Subject: Class 1 Permit Modification Notifications to the Waste Isolation Pilot Plant Hazardous  
Waste Facility Permit Number: NM4890139088-TSDF

**Class 1 Permit Modification Notifications**

**Waste Isolation Pilot Plant  
Carlsbad, New Mexico**

**WIPP Permit Number - NM4890139088-TSDF**

**Figure A4-2**  
**WIPP Traffic Flow Diagram**

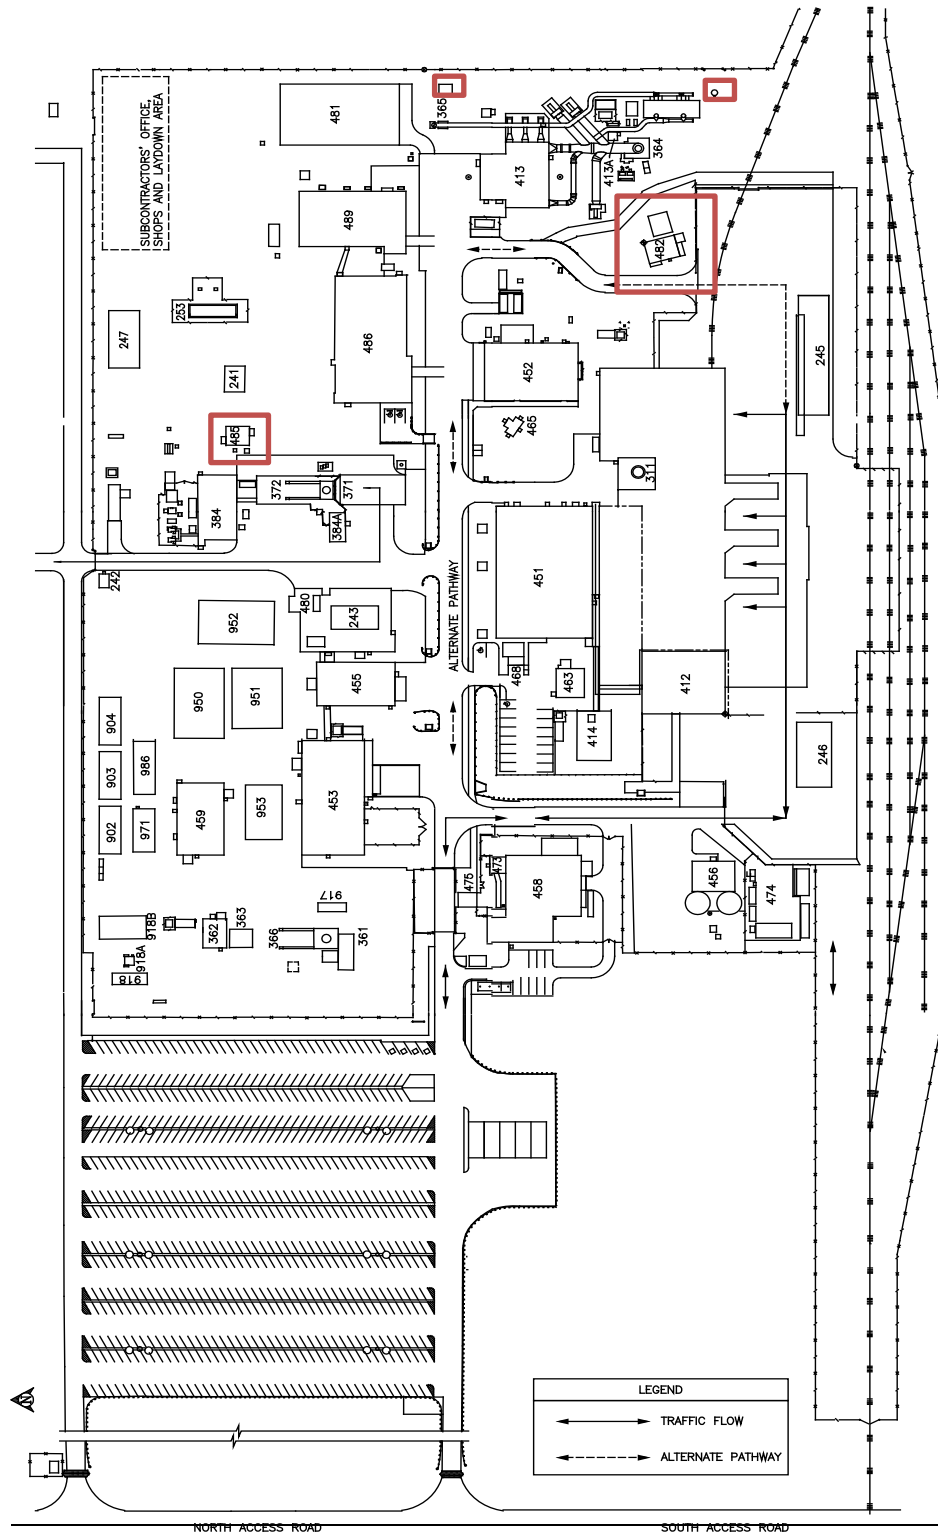
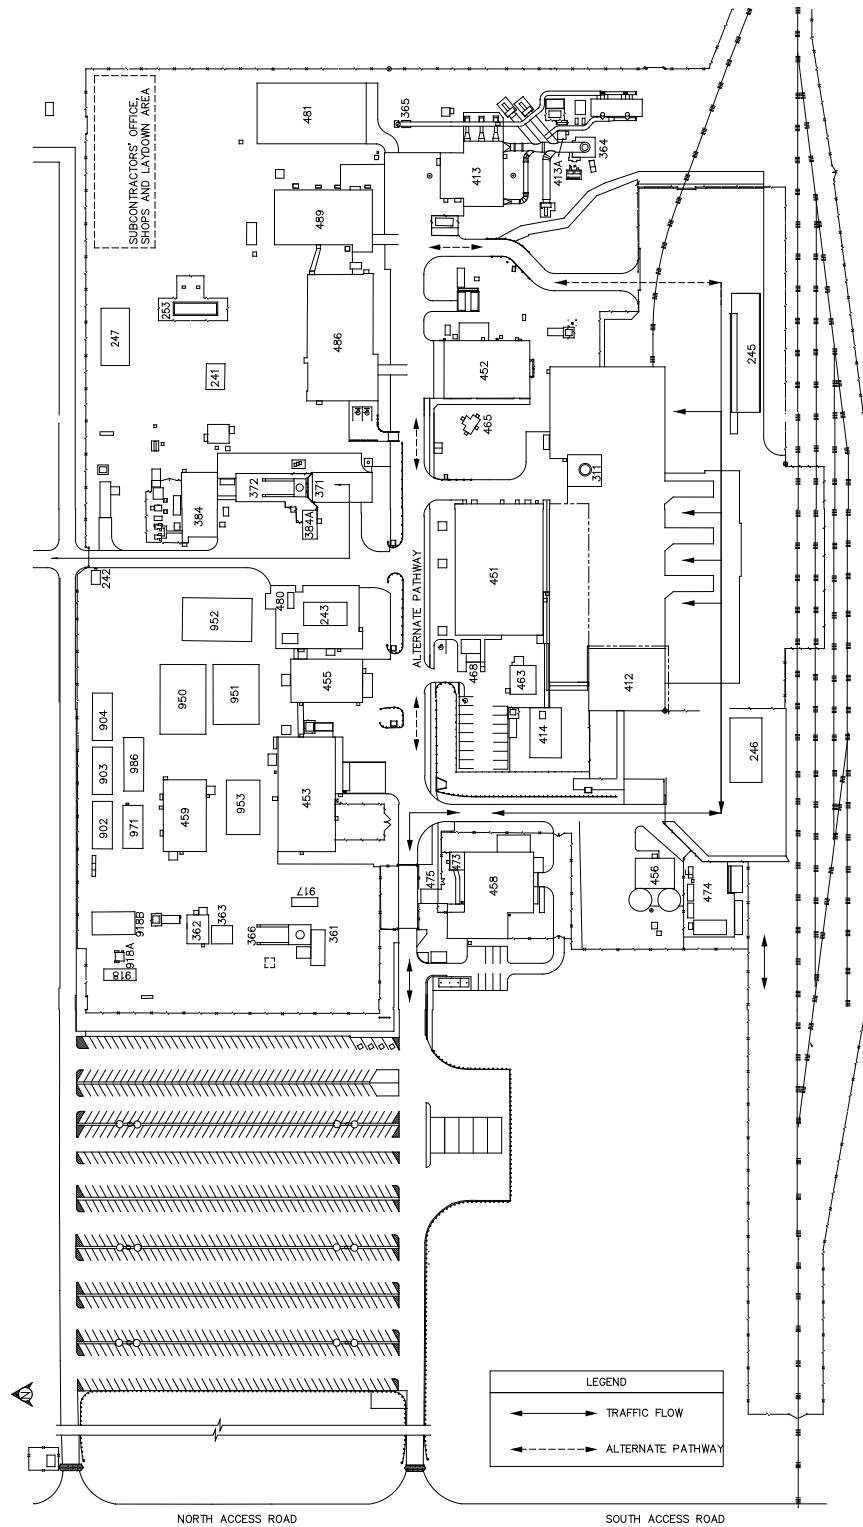
This modification updates some figures in the Permit to show the removal of surface buildings and structures at the WIPP facility. Modifications to surface structures resulting from the initiation of the New Filter Building (**NFB**) construction process; include demolition and removal of the following:

- Building 482, originally used as a hoist house;
- Old hoist pad east of Building 482;
- In-ground TRUPACT container formerly used for confined space training; and
- 13' x 17' concrete spill containment pad east of Building 365.

Additionally, Building 485, Sullair Compressor Building, has been demolished and replaced with modular compressor units that will be placed on the existing cement slab; therefore, the "485" label is being removed from the figures, but the cement slab remains in place. The Permittees are also correcting the spelling of "Echuast" to "Exhaust" in Permit Attachment D, Figure D-1a-NFB.

These changes are needed to update the Permit figures to depict the most current layout of the surface structures at the WIPP facility. For clarity, red boxes are provided on the versions of the figures being replaced to depict the specific buildings and structures that have been removed from the new figures. The revised Permit figures (the figures depicting the changes and revised figures incorporating the changes) are included below.

**Figure D-1a-NFB,  
Legend to Figure D-1-NFB (Building 416)**

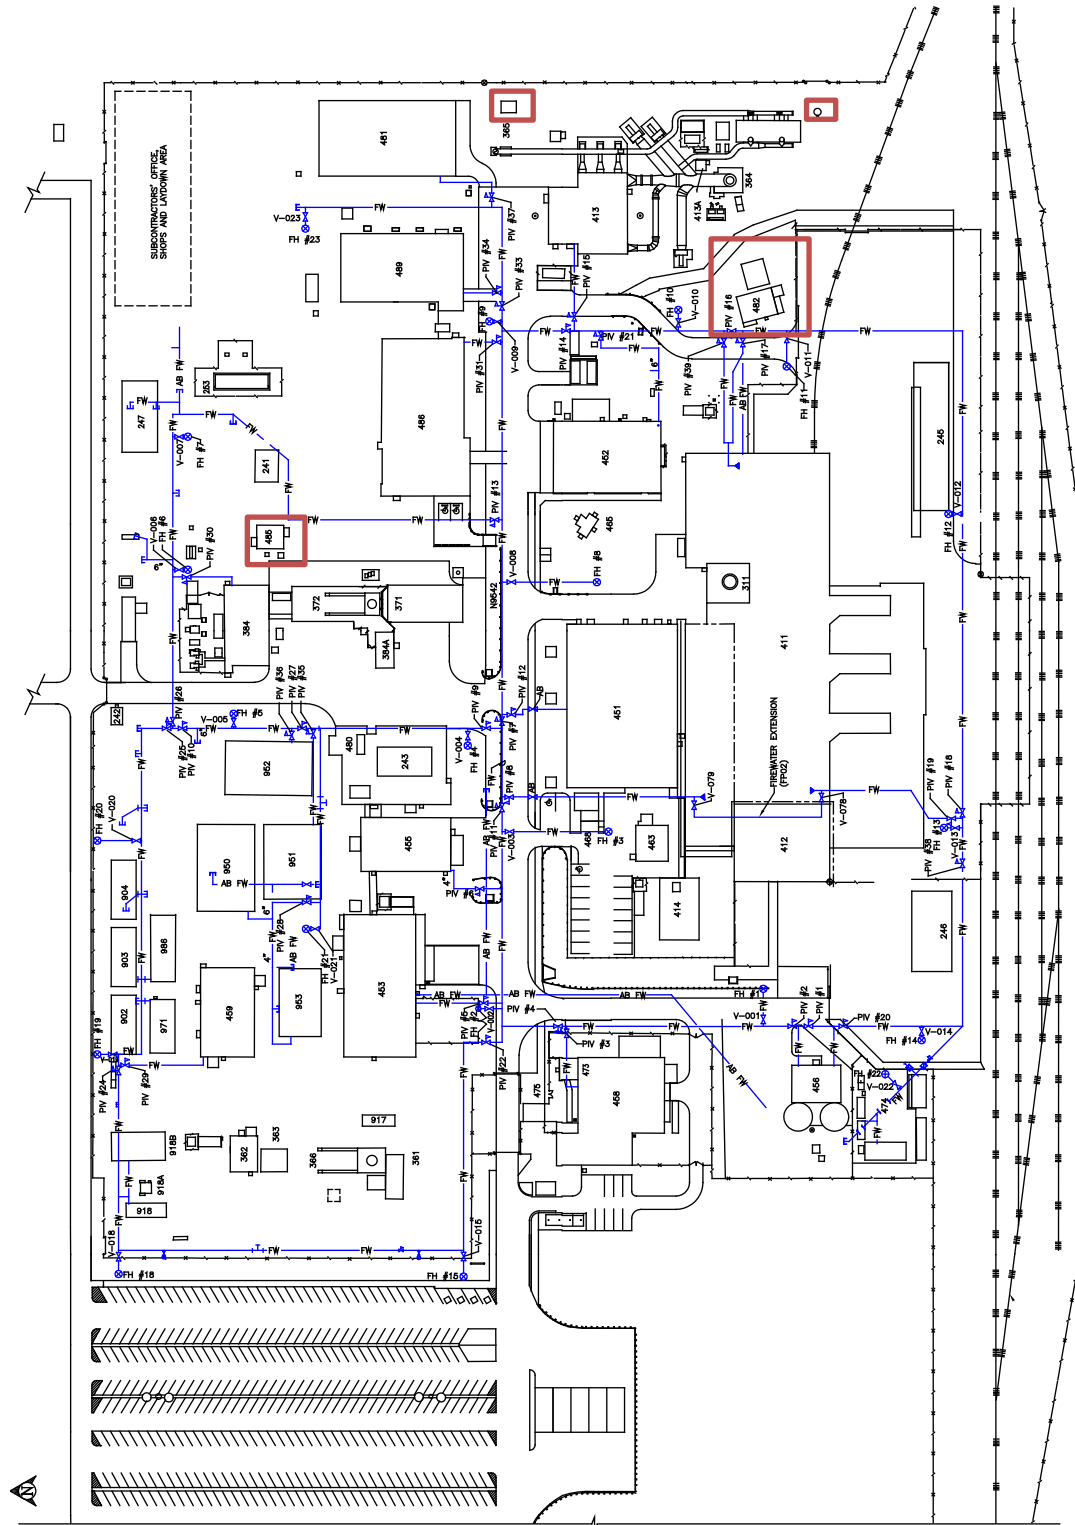
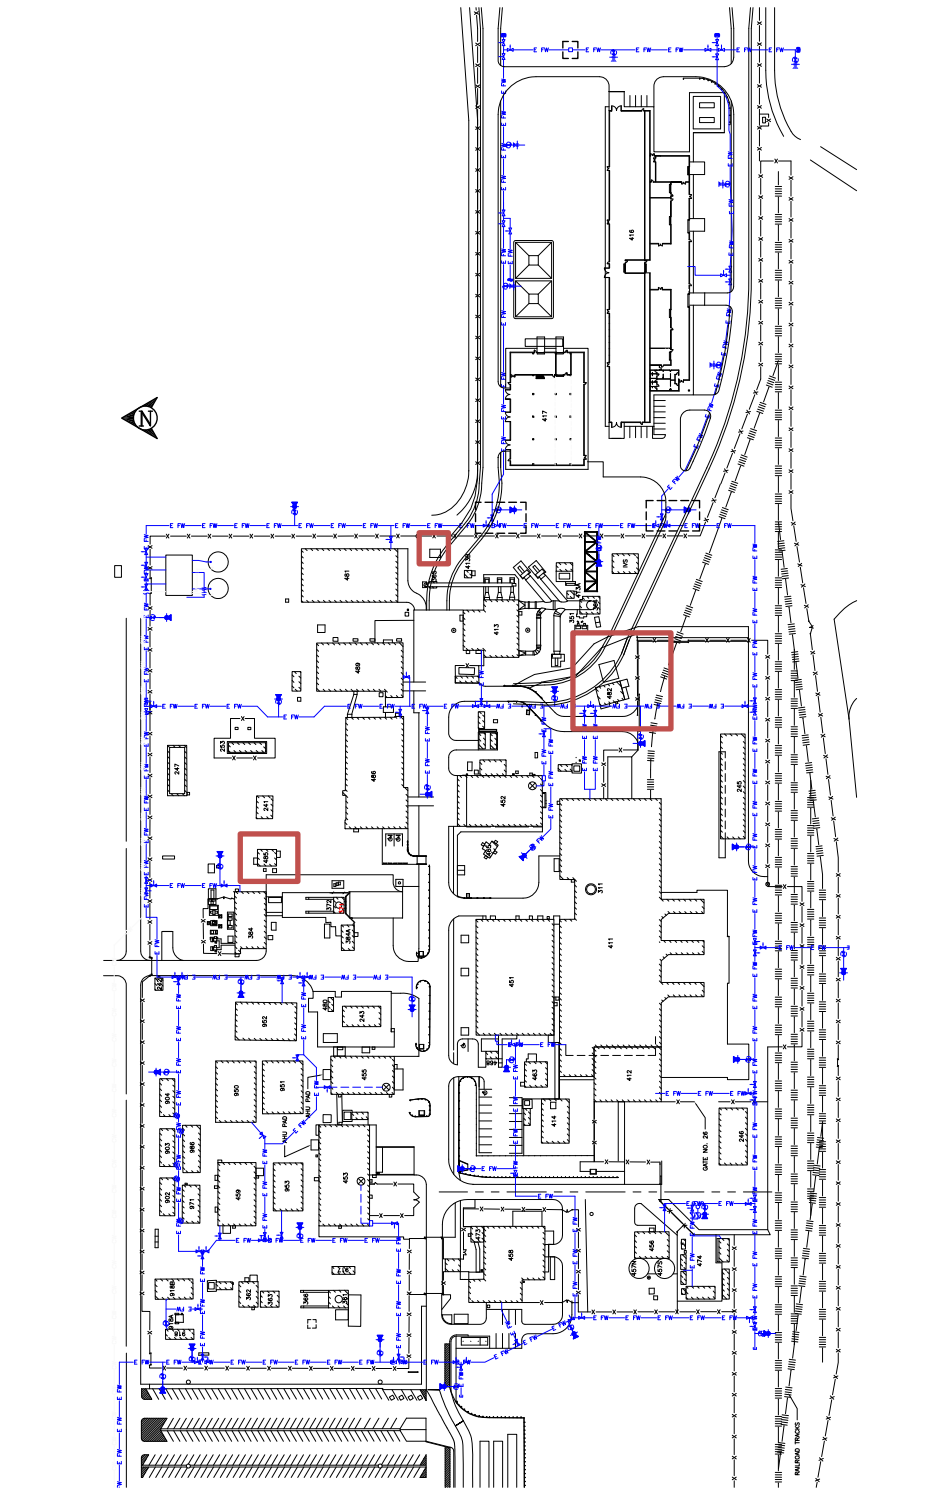
In addition, the Permittees are correcting the spelling of “Echuast” in Figure D-1a-NFB for Building 413 to read “Exhaust.”

**Figure D-3**  
**WIPP Underground Facilities**

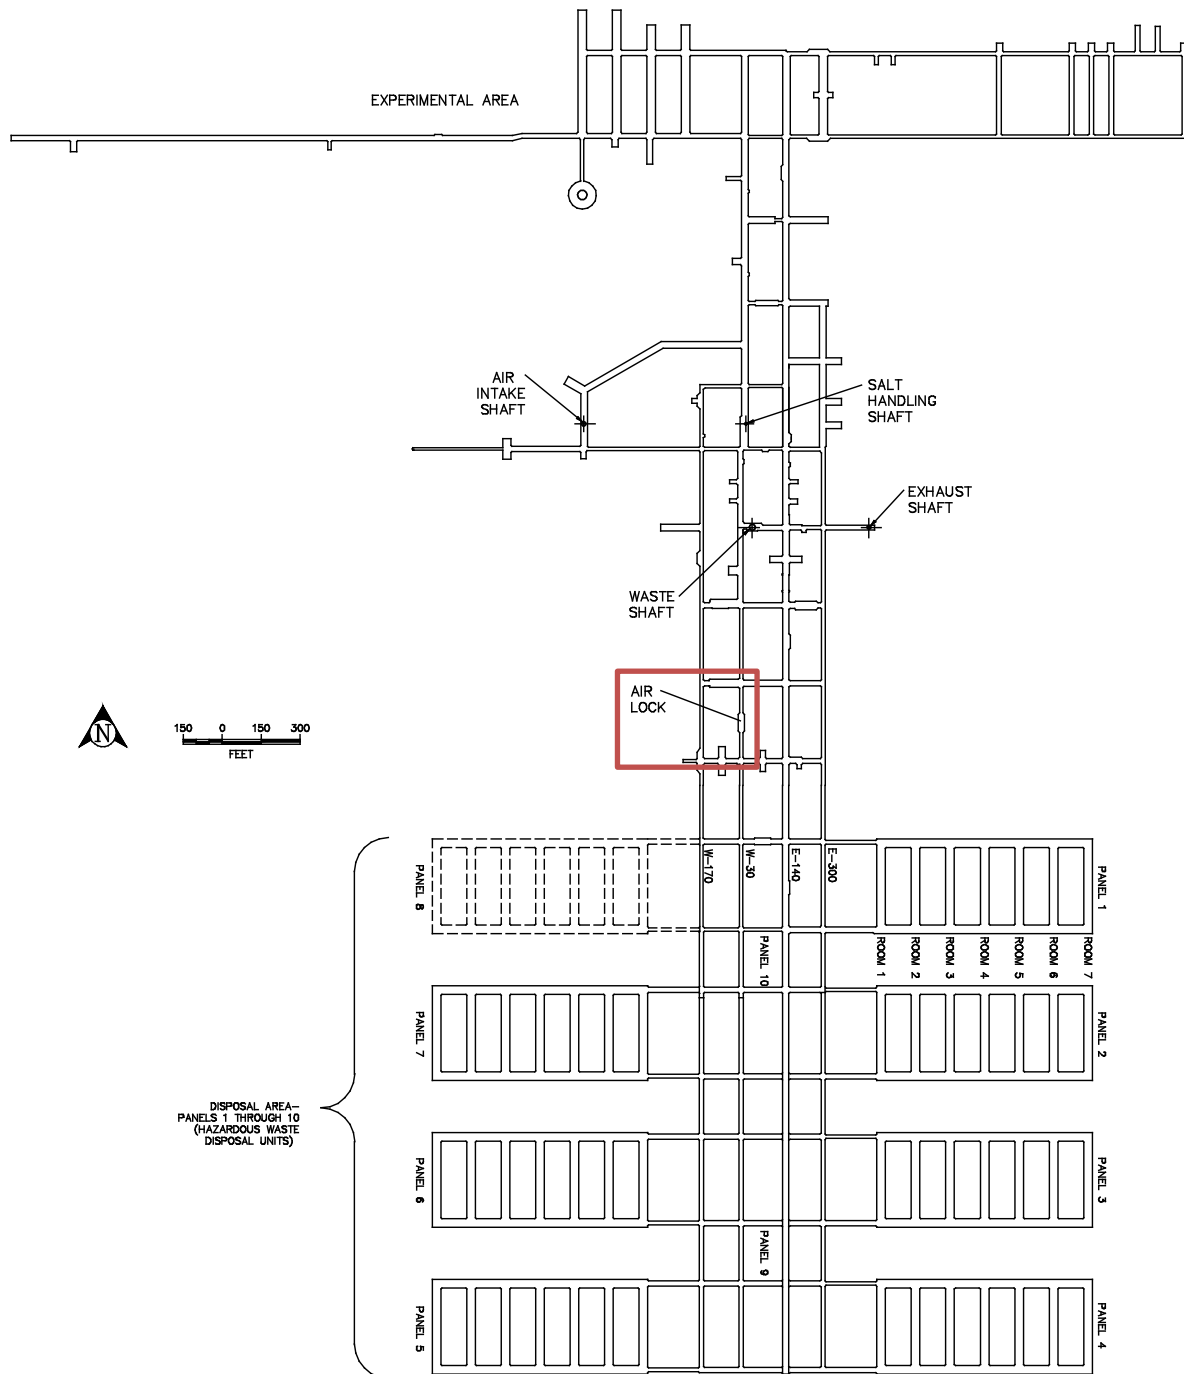
This modification updates Permit Attachment D, Figure D-3, *WIPP Underground Facilities*, to remove the “Air Lock” label.

This change updates the figure by removing unnecessary detail from the figure. The figure is meant to depict the general underground layout and is not meant to provide details such as air lock locations. Furthermore, the location of the air lock is no longer current. Therefore, this change is needed to remove outdated information. For clarity, a red box is provided on the figure being replaced to depict the detail that has been removed from the new figure. The revised Permit figure (the figure depicting the change and the revised figure incorporating the change) is included below.
